**FINDINGS AND RECOMMENDATION
OFFICE OF PLANNING AND ZONING
ANNE ARUNDEL COUNTY, MARYLAND**

CASE NUMBER: 2024-0179-V

REQUEST

The applicants are requesting a variance to allow identification signs for the name of a tenant in a business complex on more facades than allowed, to allow identification signs which project above the roof of a structure, and to allow a freestanding sign for a tenant in a business complex on property located at 595 Ritchie Highway in Severna Park.

View from Rt 2 northbound approaching the intersection of Rt. 2 and McKinsey Road. Subject

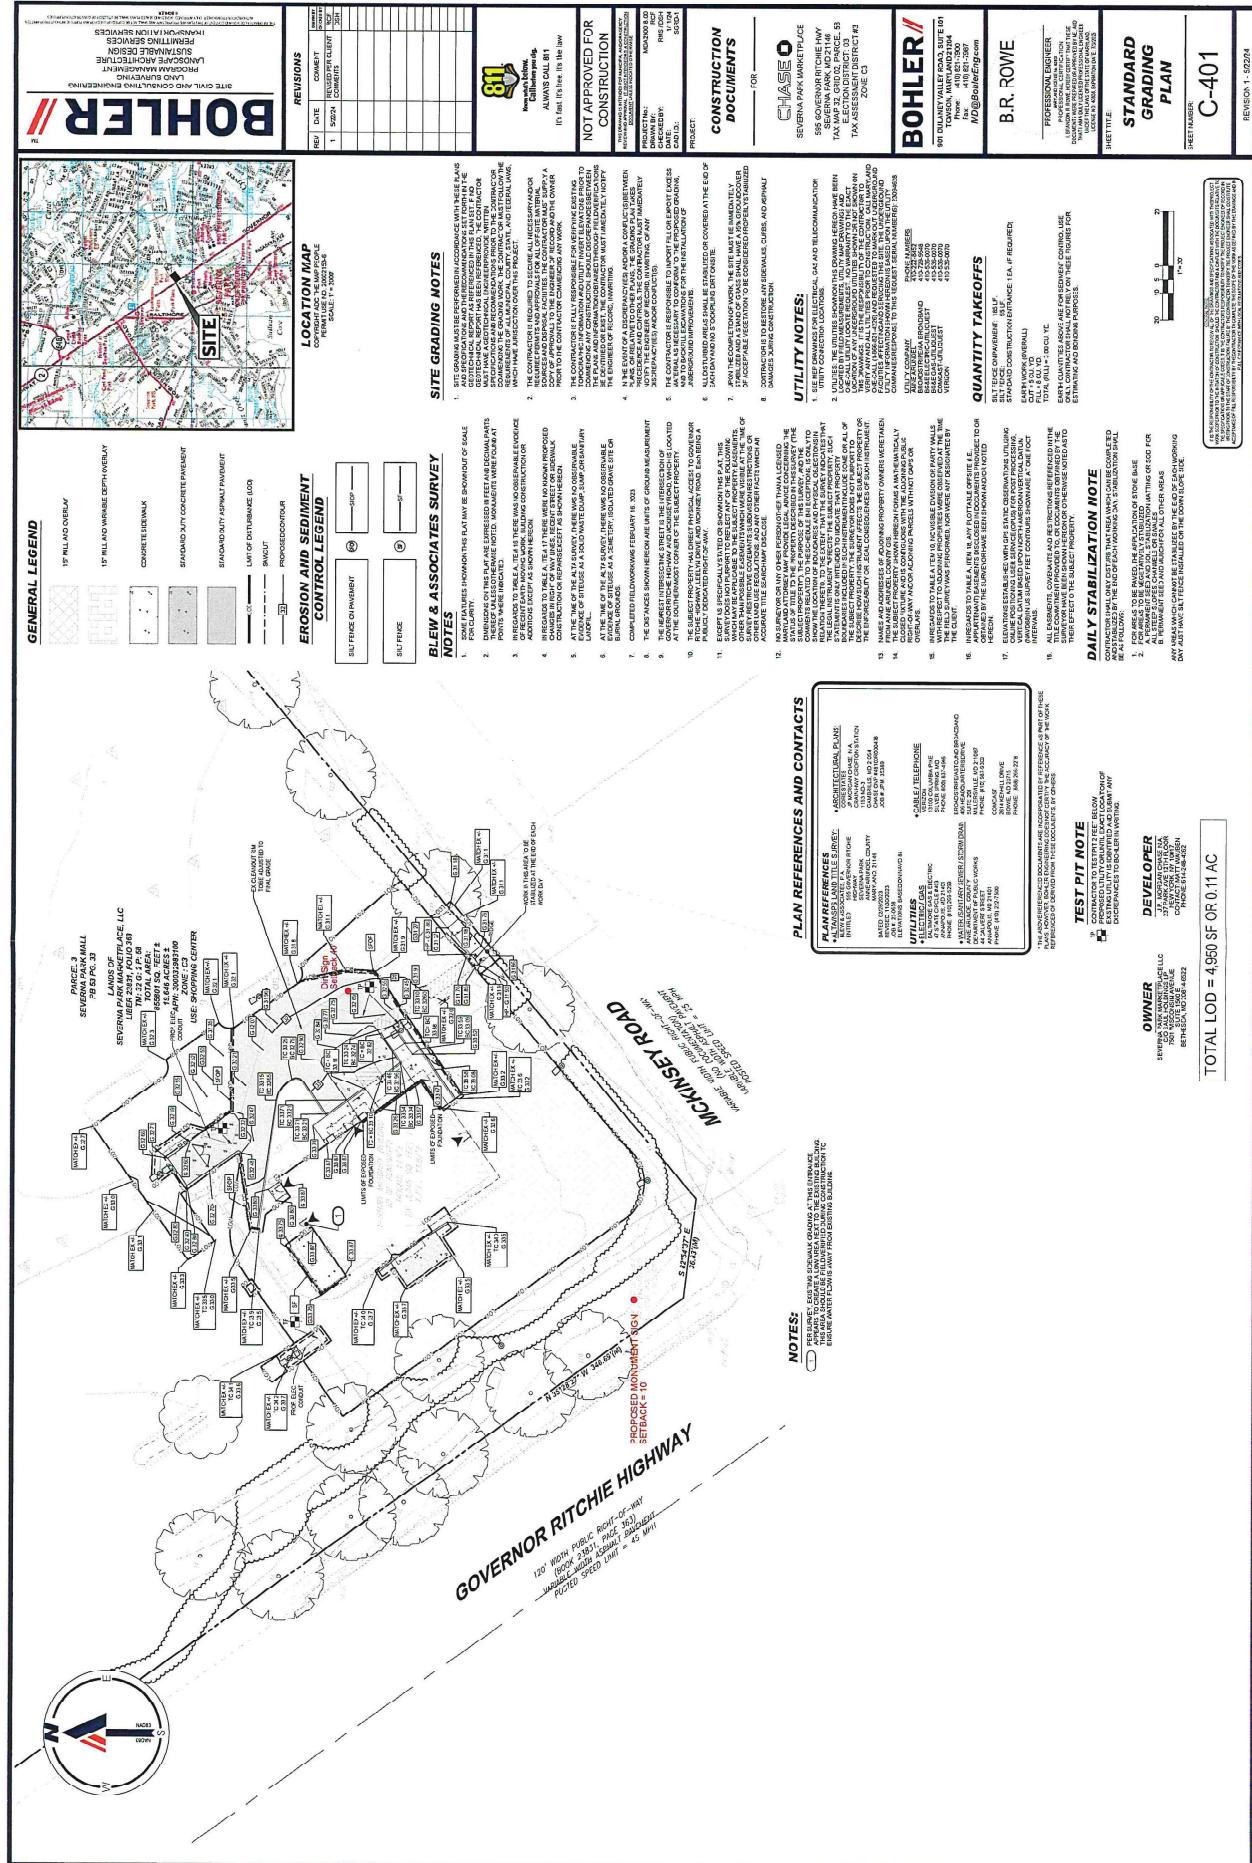
This Office submits two photos regarding the location of the existing building. The building can clearly be seen from a distance northbound on Rt. 2. Signage would include a brand designation (the blue octagonal symbol) which would aid in the ability to see the business location.

Southwest Elevation

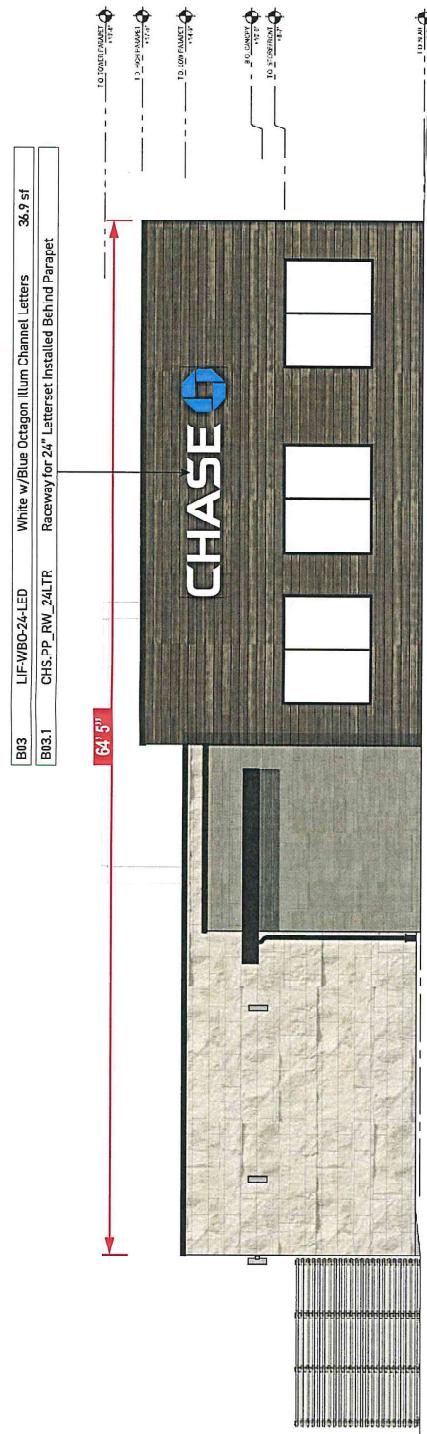
§ 18-3-308(b) of the Anne Arundel County Zoning Ordinance sets forth the requirements for identification signs in business complexes. The ordinance allows identification signs for the name of a tenant on not more than two facades in a one or two story structure, so long as the area of the signs does not exceed, for each tenant facade, the lesser of 10% of the area of the facade or 200 square feet. The proposed signs (B01 and B04, white lettering with a blue octagonal symbol, 14' 0-½" wide by 24" high) will meet the dimensional requirements, however, the proposal is for four identification signs therefore a variance is required for two additional signs.

§ 18-3-303(b)(4) prohibits a sign that projects above the roof of a structure. Three of the four proposed identification signs (B01, B02, and B03) would be constructed on a parapet which is above the roof of the building. The locations of the proposed signs require variances to this prohibition.

Based upon the standards set forth in § 18-16-305 of the Anne Arundel County Code under which a variance may be granted, this Office recommends denial of the proposed variance requests to § 18-3-308(a), § 18-3-308(b) and § 18-3-303(b)(4) of the Code to allow identification signs for the name of a tenant in a business complex on more facades than allowed, to allow three signs which project above the roof of a structure, and to allow a freestanding sign for a tenant in a business complex.

G01
M-40-RE

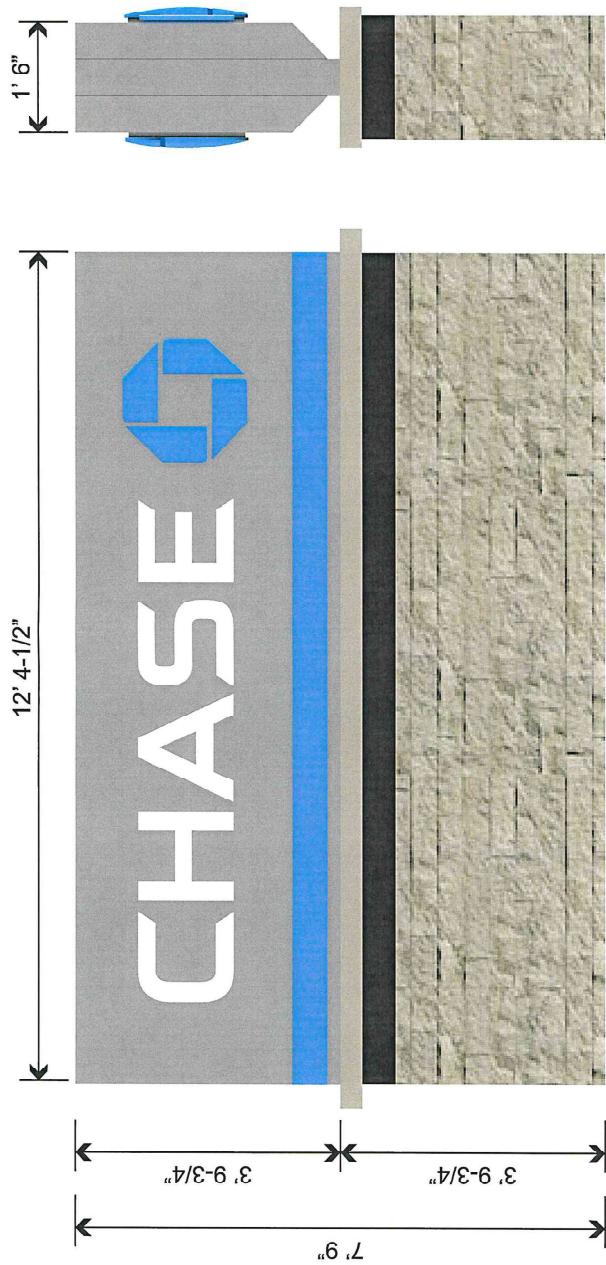
§ 18-3-308(a) of the Anne Arundel County Zoning Ordinance sets forth the requirements for freestanding signs in business complexes. The ordinance allows that a business complex may have one freestanding sign at each road frontage. The area of the sign may not exceed the lesser of 400 square feet or one square foot for each one foot of road frontage. The height of the sign may not exceed 40 feet. The proposed double-faced monument sign (G01, 12' 4-½" wide, 7' 9" high and 1'6" deep, 47.2 sf) will meet the dimensional requirements, however, it will be an additional freestanding sign. The shopping center has a freestanding sign at the entrance on McKinsey Road and at the entrance on northbound Rt. 2 therefore a variance is required for the additional freestanding monument sign.

It might be argued that with four signs on the building there is no need for a monument sign at this location; however if one were to drive either north or south on Governor Ritchie Hwy they would realize that a monument sign at this location could actually prevent quick stops and even future accidents.

When driving north, because of the trees, and some other businesses which are setback the same distance as the bank's building, you do not really see the bank until you are right at McKinsey Rd. At that point in time it would be too late to get into the right lane to turn right onto McKinsey Rd. at this busy intersection, which may result in traffic difficulties. If there were a monument perpendicular to Governor Ritchie Hwy, it could be seen from a distance and allow traffic to make decision prior to this intersection and be in the right lane well ahead of McKinsey Rd.
